SALAMANDER SHORES HOTEL REDEVELOPMENT

PREFERRED PROJECT REPORT & RESPONSE TO SUBMISSIONS

prepared for:
Department of Planning NSW

February 2011

The revised Concept Plan with key changes to the residential Building H.

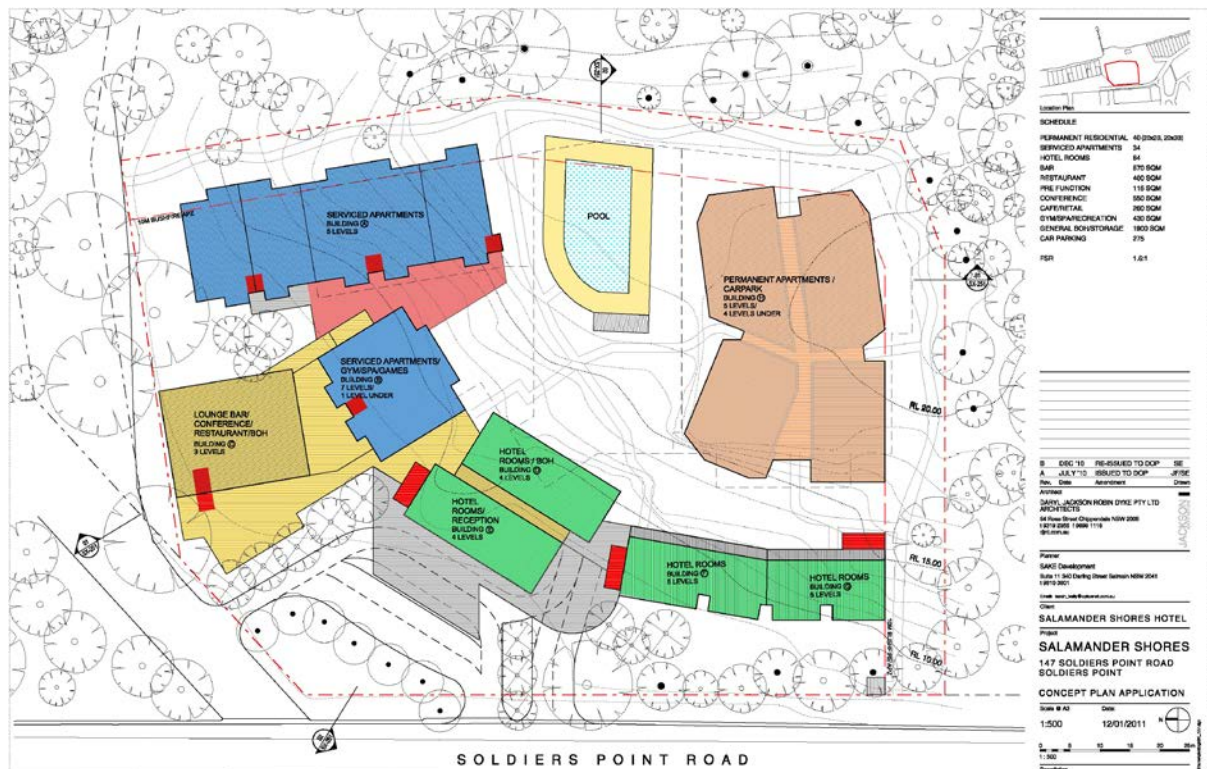
3) Permanent Residential Building (Building H):

(a) Reduce the width to improve internal amenity and reduce bulk and scale.

(b) Building A is a suggested location for Building H. This would improve residential amenity and satisfy aspects of SEPP 65.

As this is a concept plan, the building footprint has been designed to enable some flexibility and adjustment of floor plates at the detailed design / DA stage. Notwithstanding, significant redesign to Building H has occurred to address the above comments particularly to reduce the bulk and scale, reduce the north south width and improve solar access and cross ventilation to future apartments.

The internal lobby and circulation space has been significantly reduced and a central void / atrium proposed along the north south and east west axes. These breezeways will improve access to natural light and cross ventilation. The building footprint has also been reduced, particularly along the northern and western facades, being setback up to 10 metres in some areas. The number of permanent apartments has therefore been reduced to 40 units. The new design substantially breaks down the building reducing its bulk and scale.

- new internal breezeways and roof skylight that provide natural light and air;
 - modified balcony designs including reduced areas that encroach into the 10m asset protection zones; and

- an overall change in the building layout and footprint including significant articulation along the northern façade with a faceted face to provide visual interest and reduce the bulk of the building footprint.
